RE: FERC Project No. 2079 - CA

Middle Fork American River Project

Addendum to the May 2004 PMF Determination Hell Hole, Interbay, and Ralston Afterbay Dams

# Addendum to the May 2004 Probable Maximum Flood Determination (final)

## **Exhibit 1: Probable Maximum Storm Temporal Sequences**

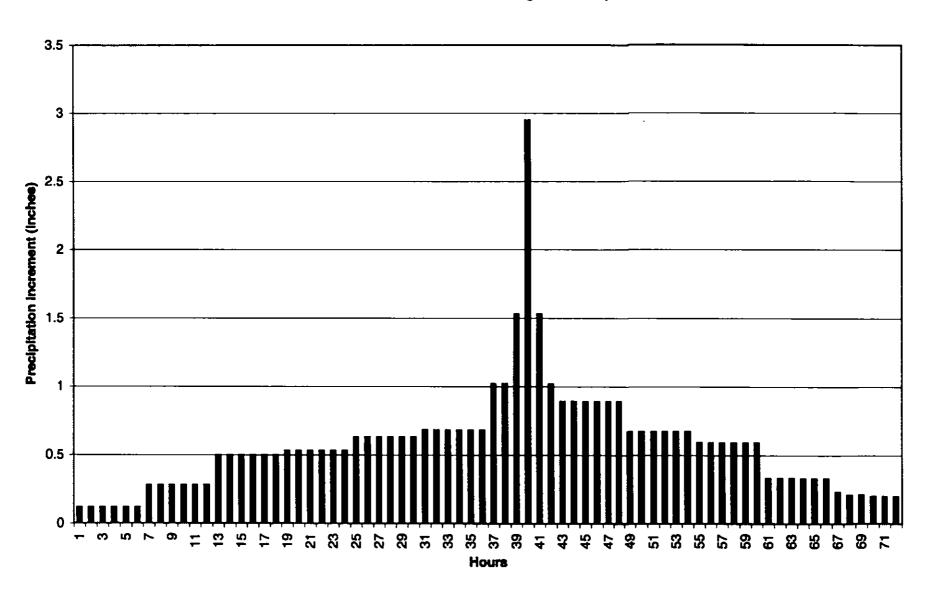
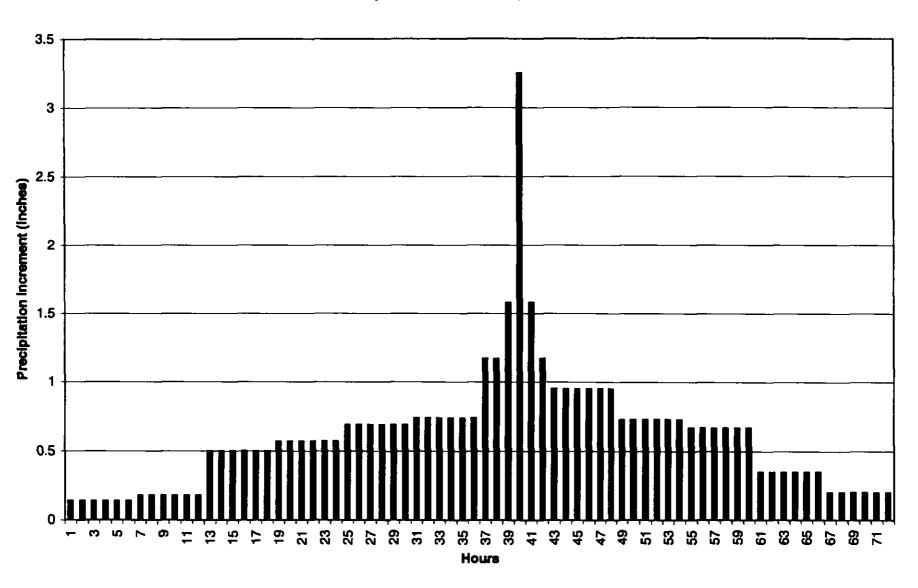
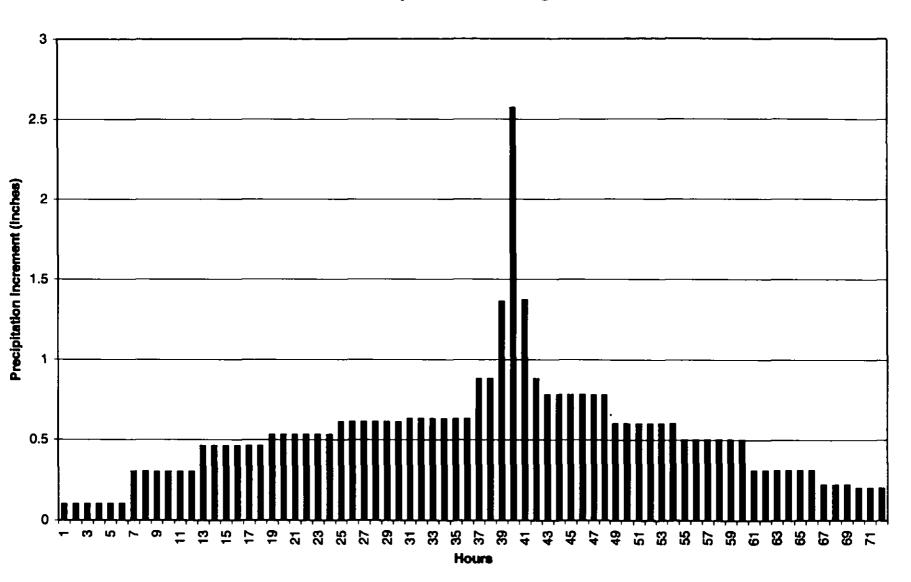
- The temporal sequence of the PMP has been re-ordered to place the peak 6-hour increment between hours 37 and 42, and the peak 1-hour precipitation increment at hour 40. Temporal sequences of temperature and wind were also adjusted to follow the new PMP temporal pattern.

The application of procedures in HMR 58 for developing the PMP sequence was unchanged from the 2004 study, except for the temporal reordering of the increments of the storm. In the 2004 study, the peak increment of PMP rainfall was placed at hour 33 of a 72-hour sequence. The sequence of PMP rainfall has been rearranged for the present analysis so that the peak increment occurs at hour 40. The temporal patterns adopted for the Ralston Afterbay, Interbay, and Hell Hole basins are shown in Exhibit 1. Within each of these basins, the PMP was redistributed spatially among model subbasins based on the index PMP for each subbasin, as documented in the 2004 report.
